Wisconsin Department of Transportation

Proposal #18: 2430-06-70, WISC 2017 164
Colony Avenue
7th Avenue to STH 20
USH 45
Racine County

This is Addendum No. 01, which provides for the following:

ADDENDUM NO. 01

Addendum No. 01
 ID 2430-06-70
 Revised Sheet 506
 March 31, 2017

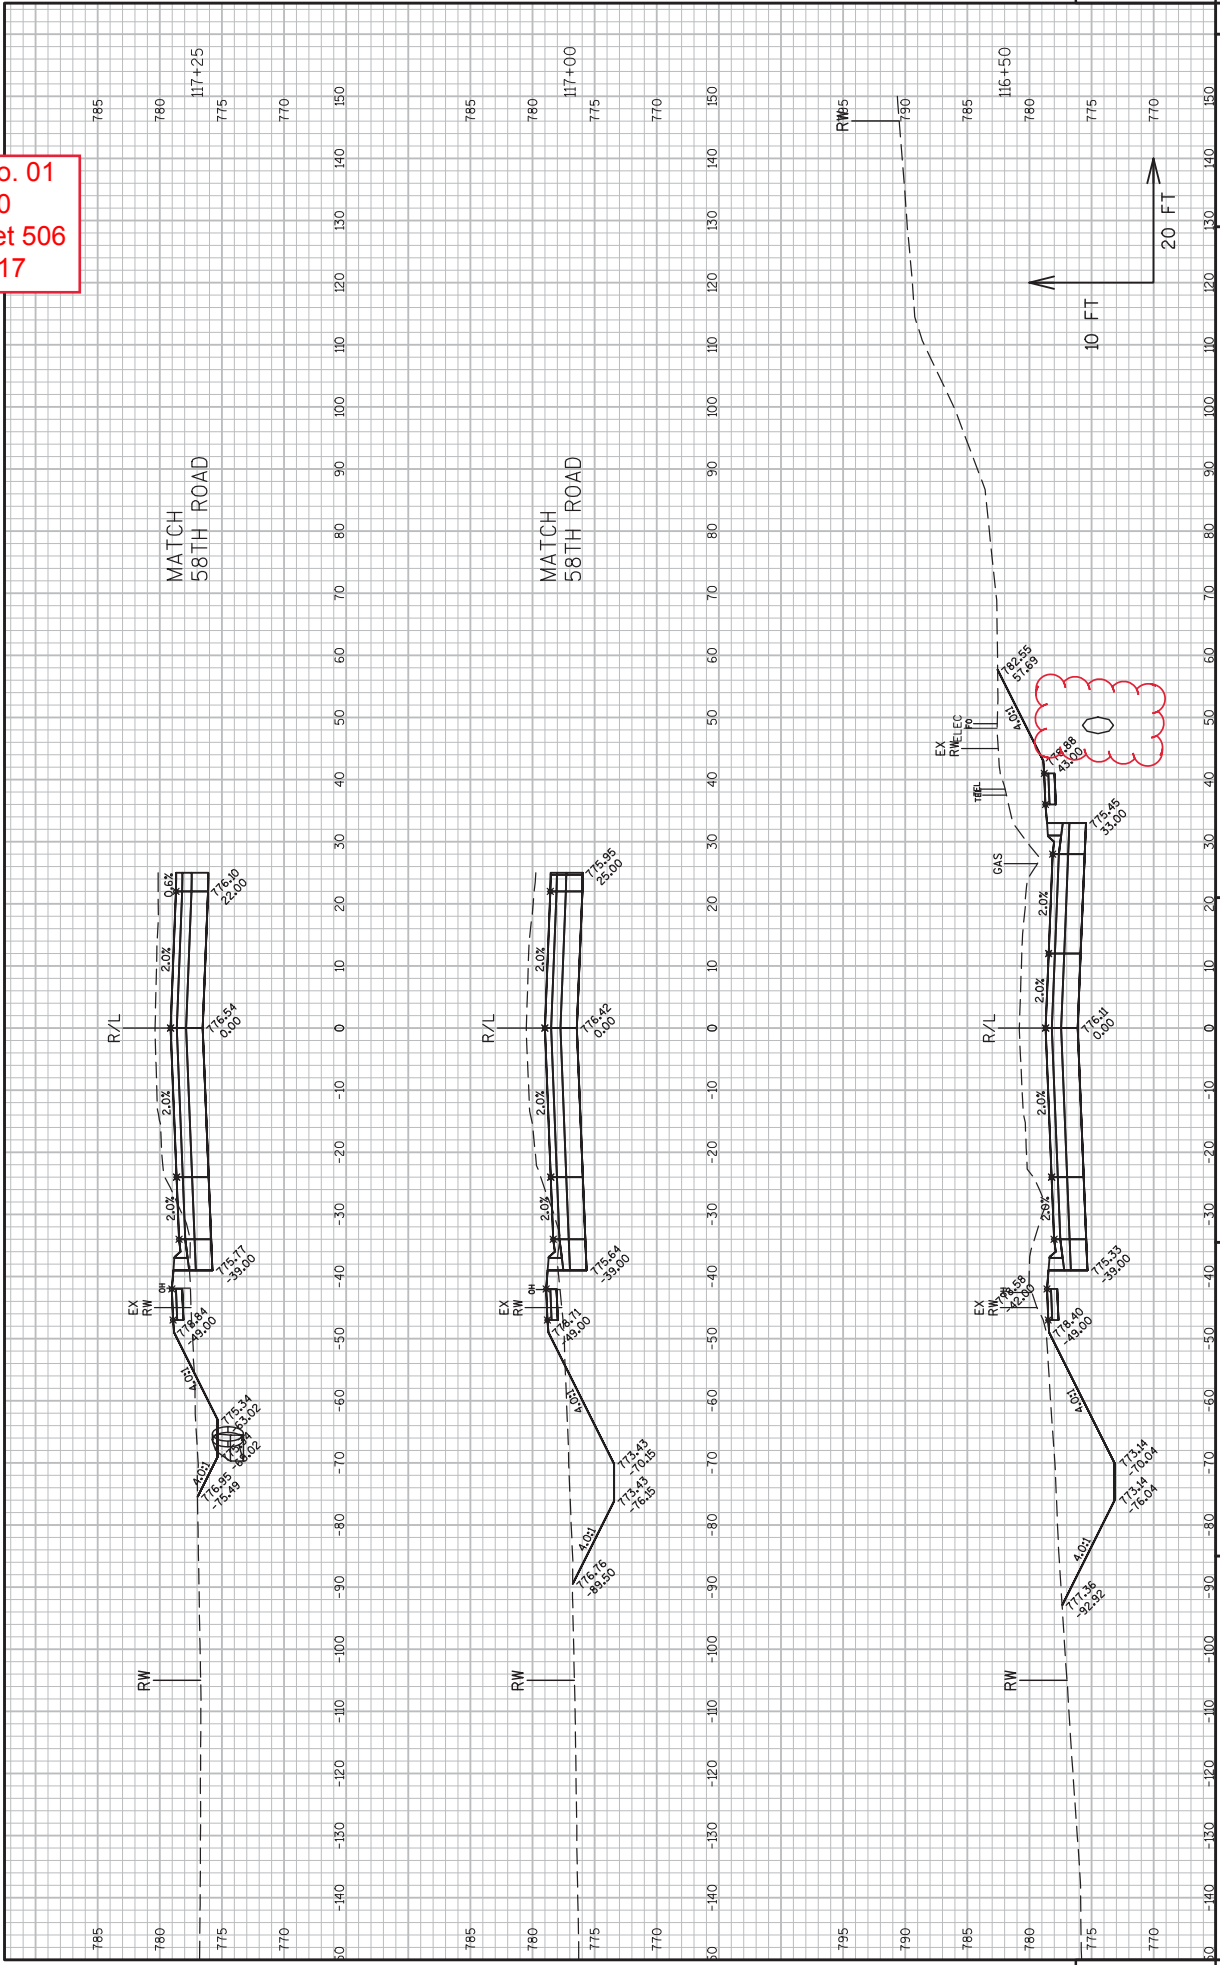
| 506 | Cross Sections: USH 45 (revised storm sewer STA 116+50) |

Addendum No. 01
 ID 2430-06-70
 Revised Sheet 600
 March 31, 2017

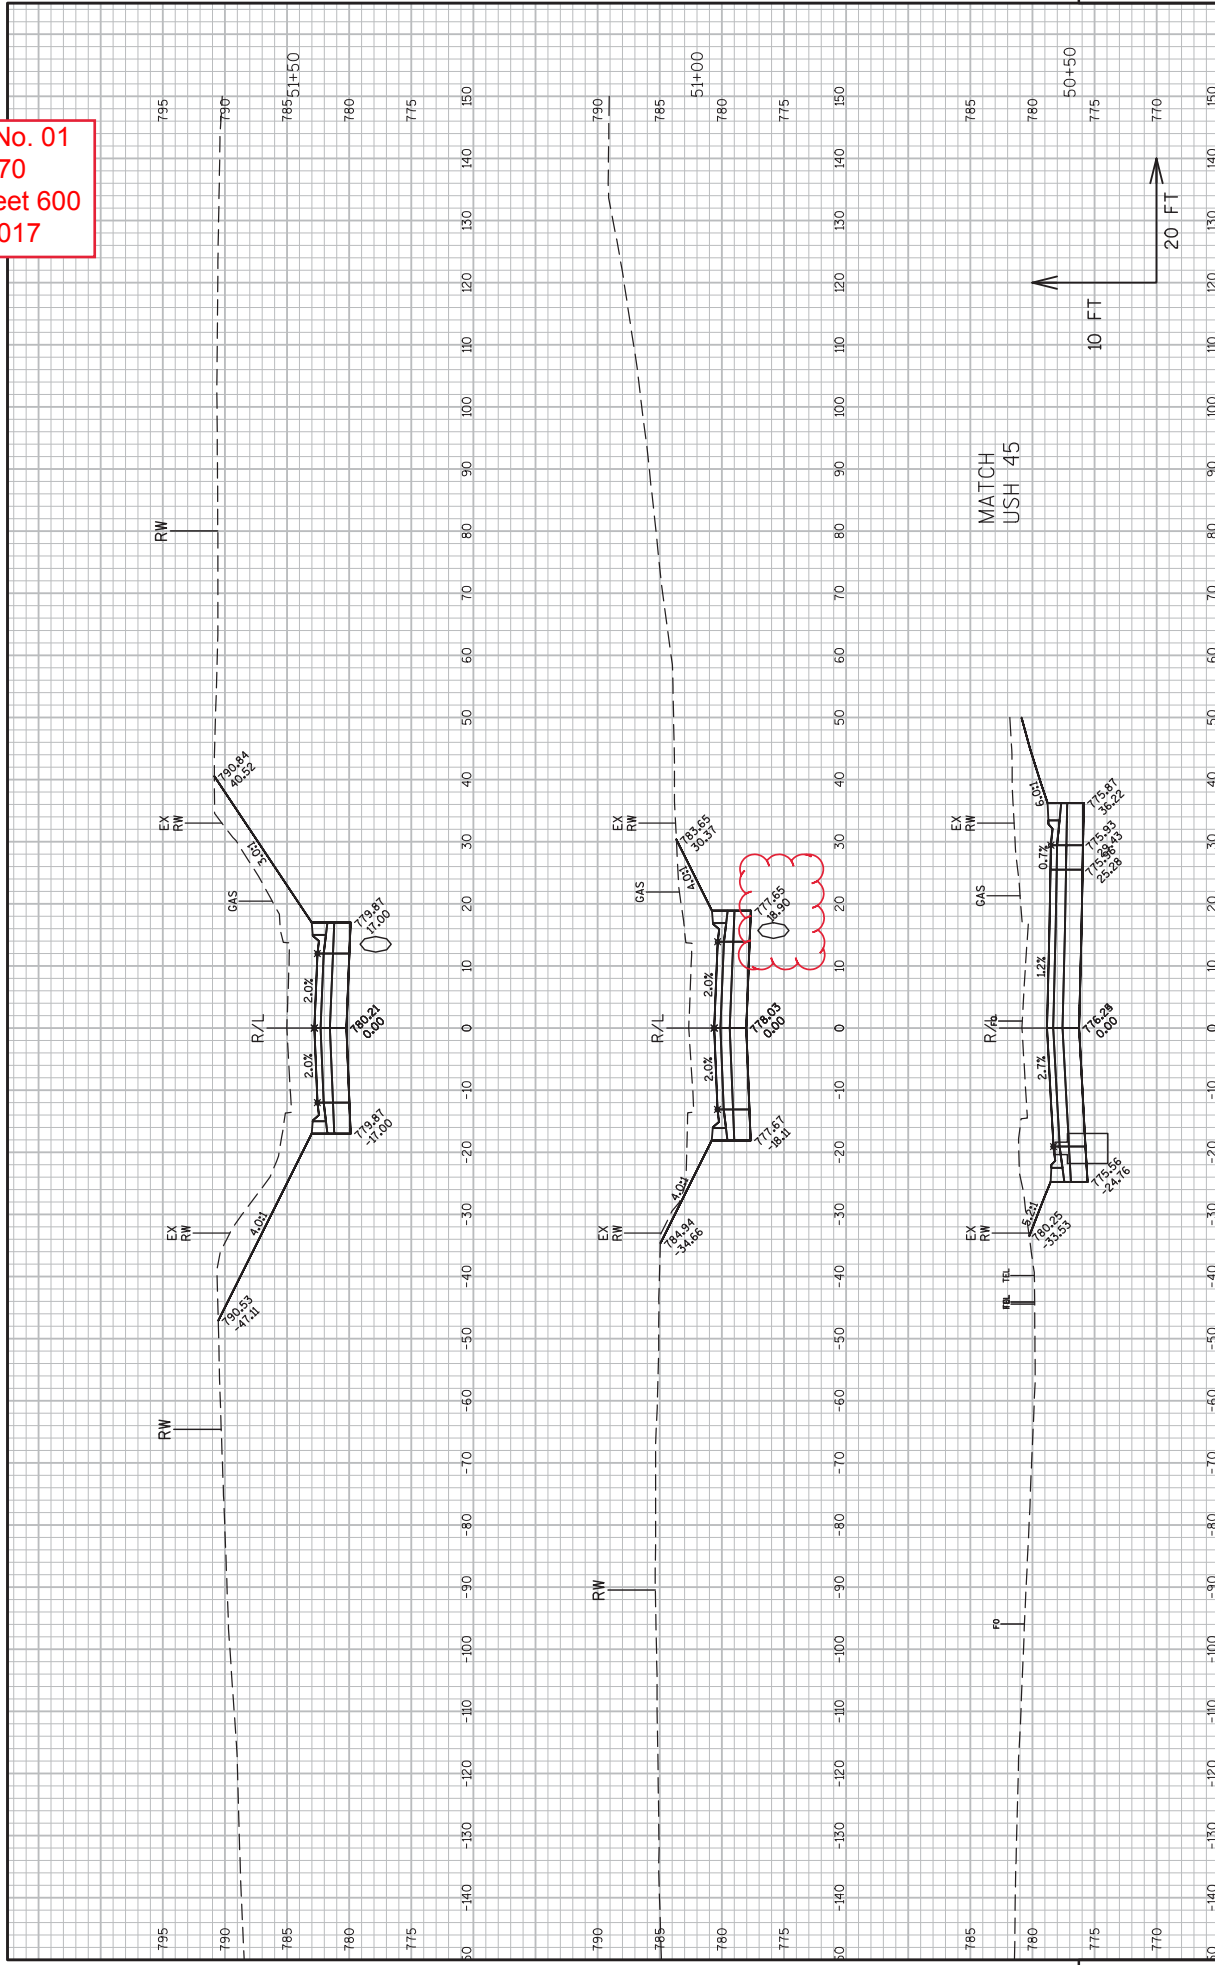
| 600 | Cross Sections: 58 th RD (revised storm sewer STA 51+00) |
